ADDENDUM NO. 4
TO
CONTRACT DRAWINGS AND SPECIFICATIONS
Dated
July 9, 2007

MAINE TURNPIKE AUTHORITY
ADMINISTRATIVE BUILDING
CONTRACT NO. 2007.07

A/E PROJECT NO. 06016

Date of Addendum Issuance: August 10, 2007

SCALE:	1" = 60'
CAD FILE:	CP101-06016
PROJECT No.	06016
REF. SHEET:	CP101
PM:	SLB
A/E:	MGJ
DATE:	8-10-07
ADDENDUM No.	ADD-4
SKETCH No.	C-1

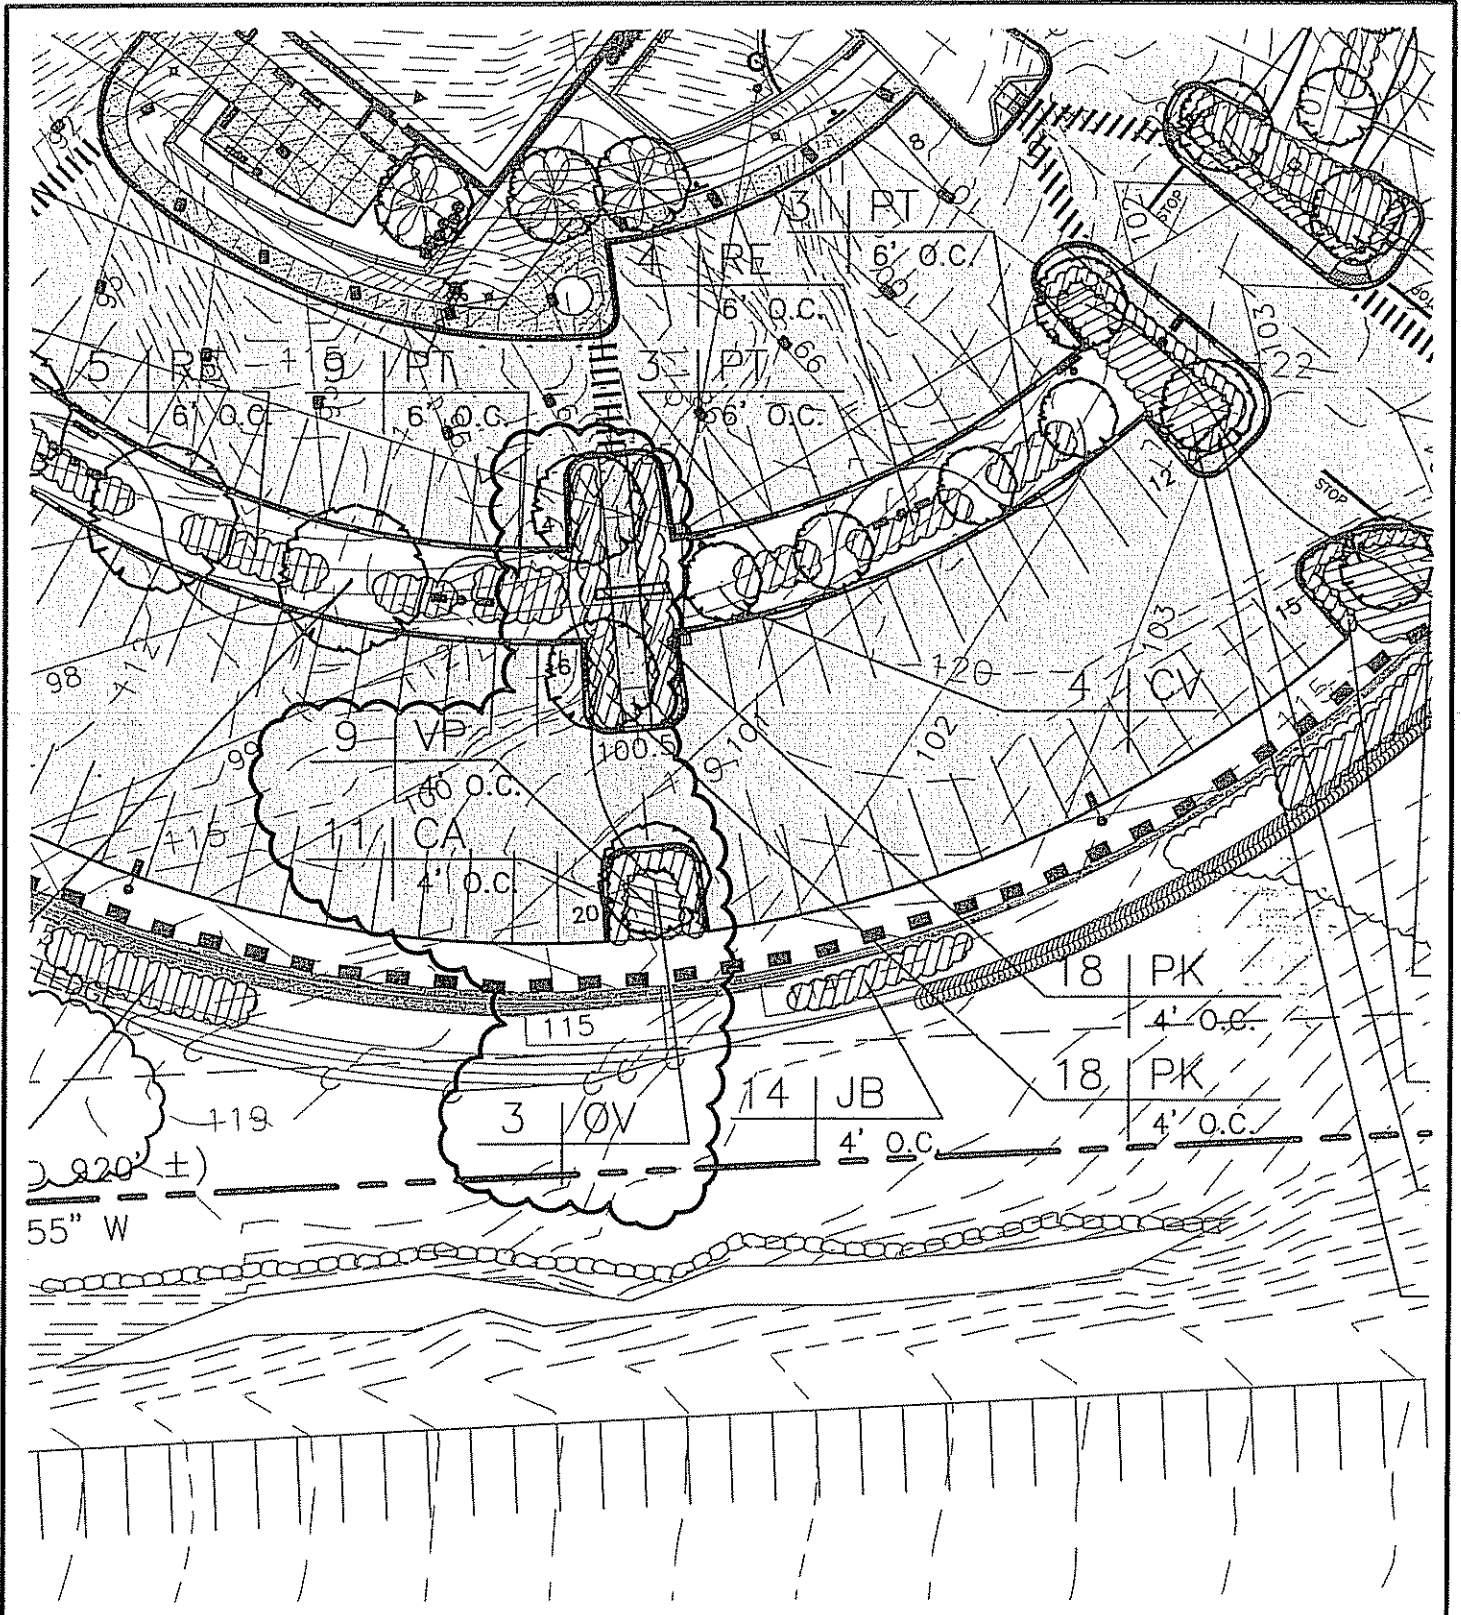
1. CP101 – LAYOUT PLAN:
 - a. Revise to include dimensioning for new paint markings on Congress Street; and , Add radius curb at District Drive and Congress Street and new paving in Congress Street for extension of right-hand turn lane from Congress on to the Airport Connector. See attached Sketch No. C-1 Congress Street & District Road.

SCALE:	1" = 40'
CAD FILE:	LP101-06016
PROJECT No.	06016
REF. SHEET:	LP101
PM:	SLB
A/E:	MGJ
DATE:	8-10-07
ADDENDUM No.	ADD-4
SKETCH No.	L-1
© COPYRIGHT 2007 SMRT INC.

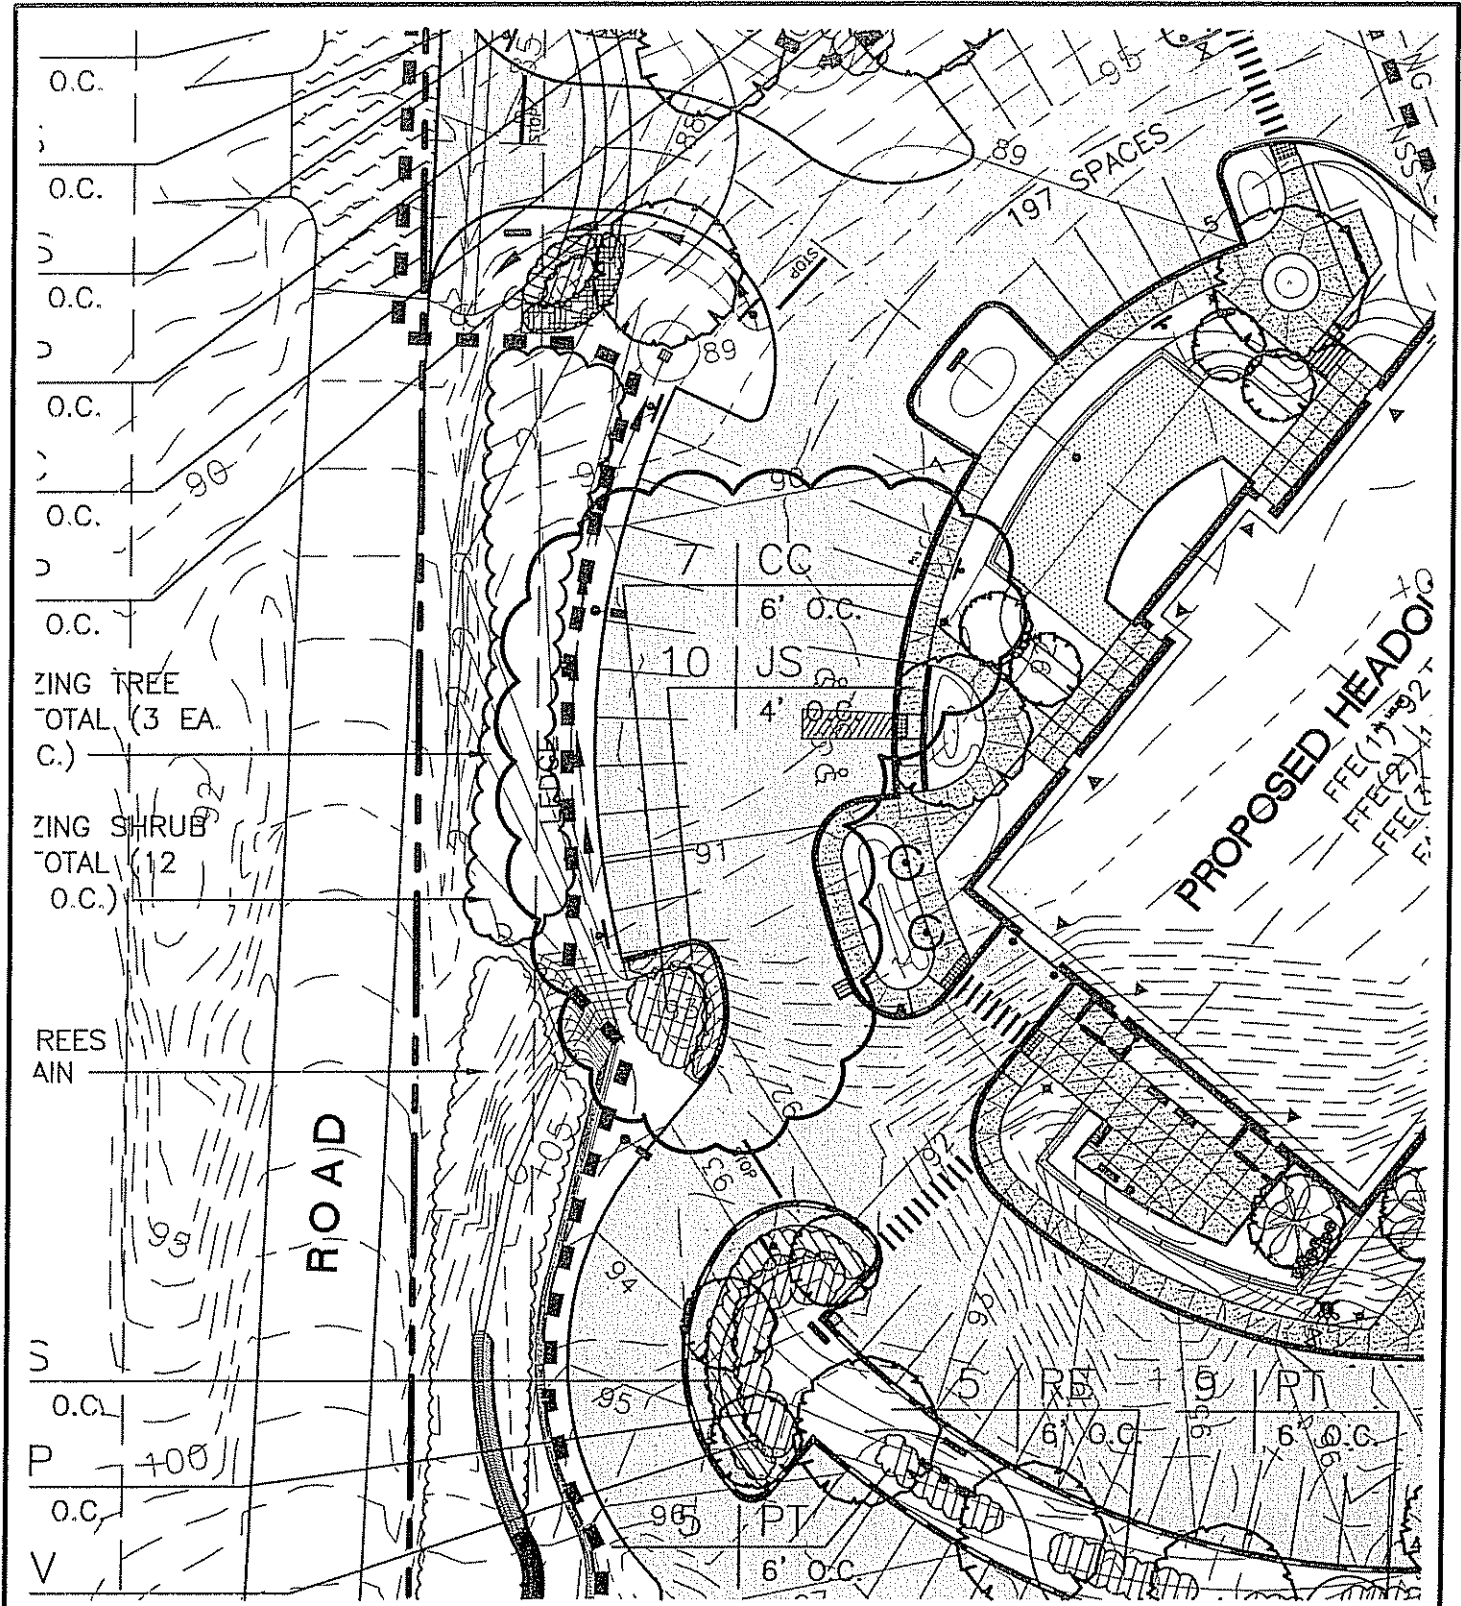
2. LP101 – LANDSCAPE PLAN:
 - a. Sketch Nos. L-1, L-2, L-3, L-4, L-5 and L-6 graphically clarify plant material requirements:
 - b. Sketch No. L-7 clarifies extent of irrigation system provided as part of this contract.

SKETCH No.
L-8

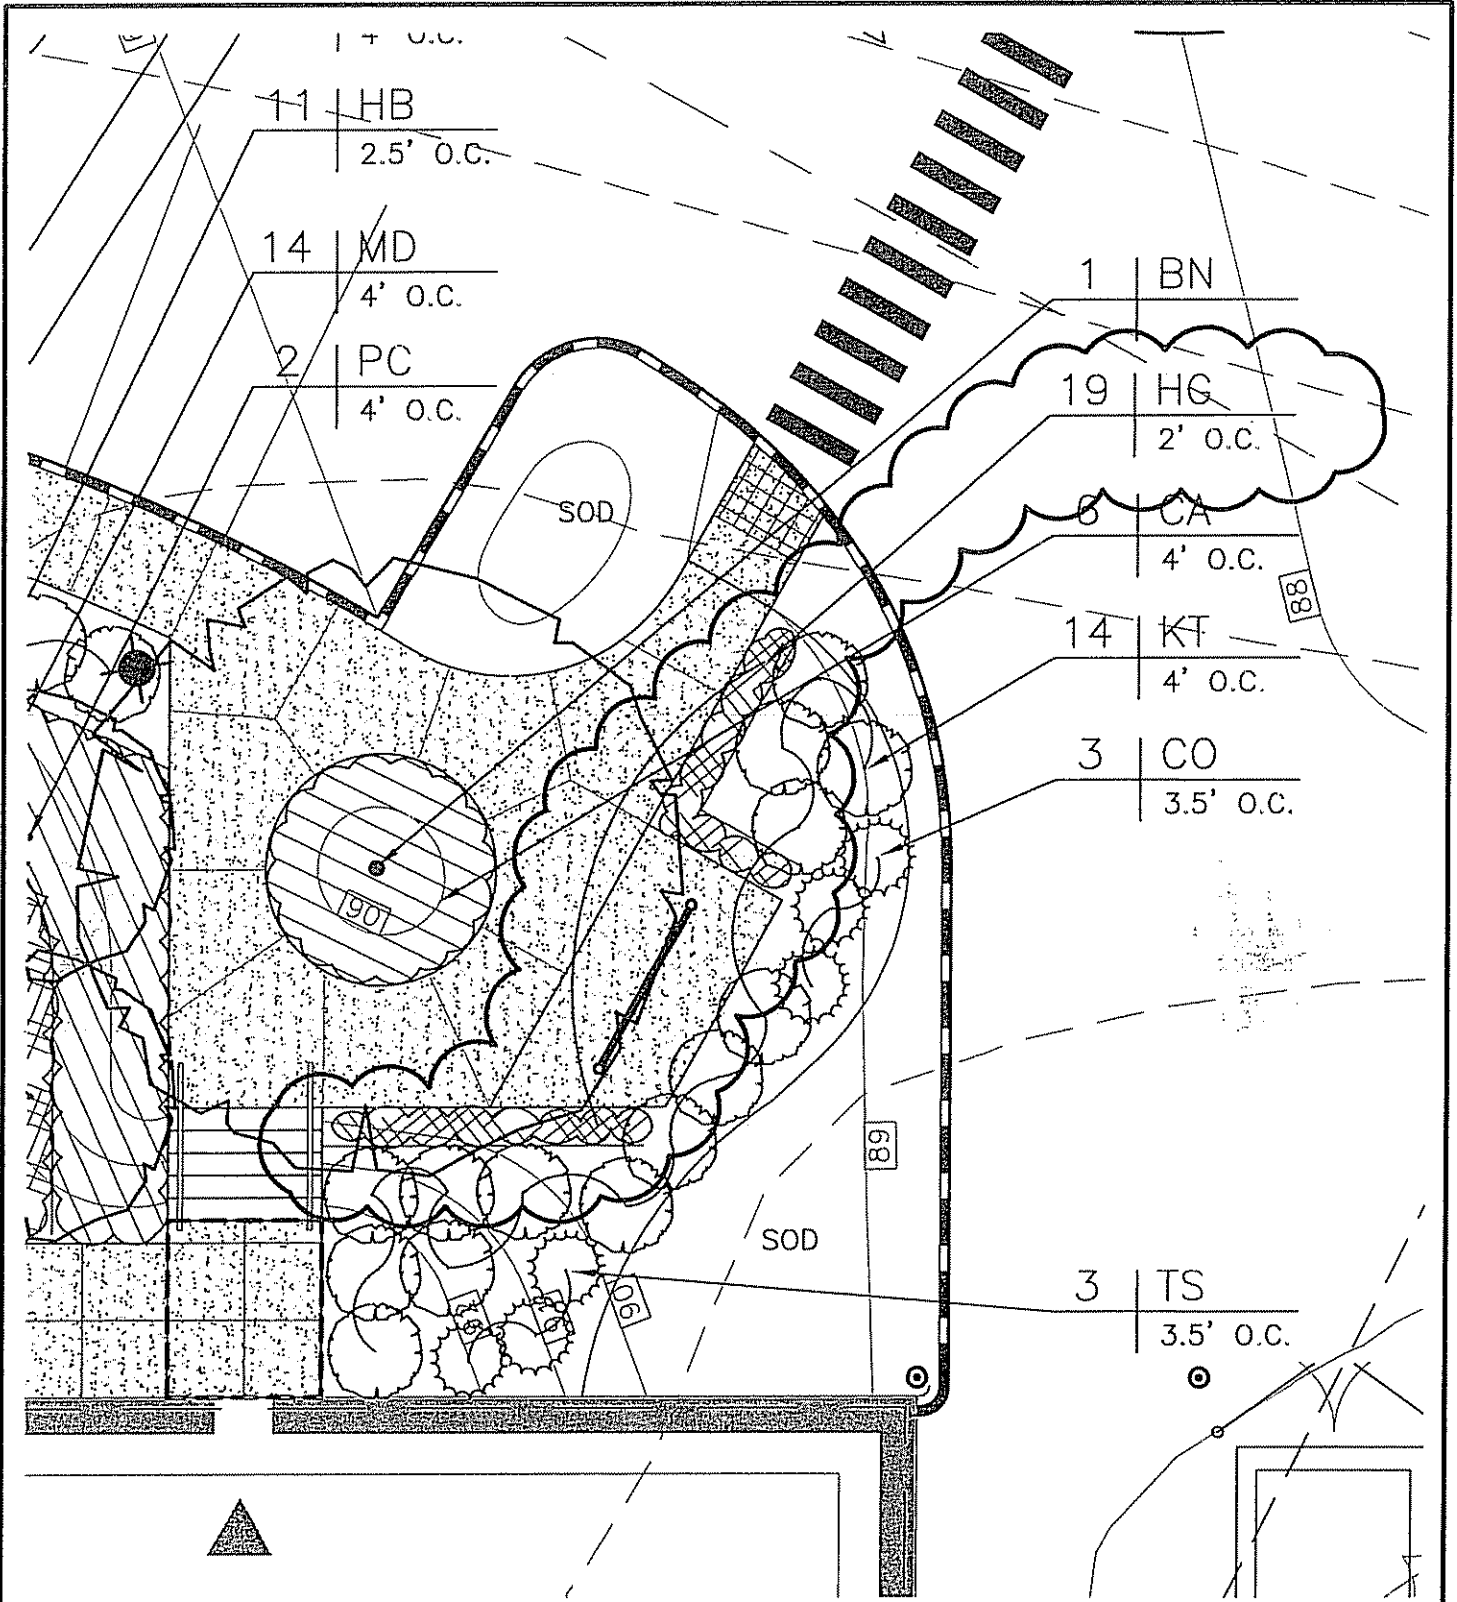
3. LP202 – DETAIL LANDSCAPE PLAN:
 - a. Sketch No. L-8 graphically clarifies plant material requirements.
 - b. Sketch No. L-9 revises plant material requirements.
